Technical Service Bulletin: tsb101387

Released Date: 11-Mar-2004

New Fan Idler Dust Shields, update to Procedure 008-030, Fan Drive Idler Pulley Assembly

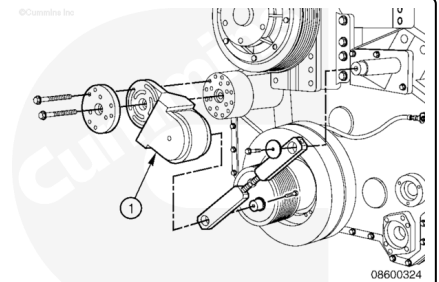
The new dust shields are installed on either side of the idler pulley as part of the Pivot Arm Assembly (1).

Note : When using dust shields with pivot arm assembly, Part Number 4066540, the use of the key shaft is not required. Fan idler bearings should be replaced with Part Number 4016800.

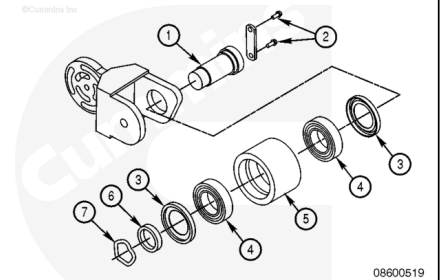
The bearings (4) mount on the idler shaft (1). The two dust shields (3), packed with grease, mount to the bearings; one at the spacer (6) side, and the other at the shaft shoulder (1) side.
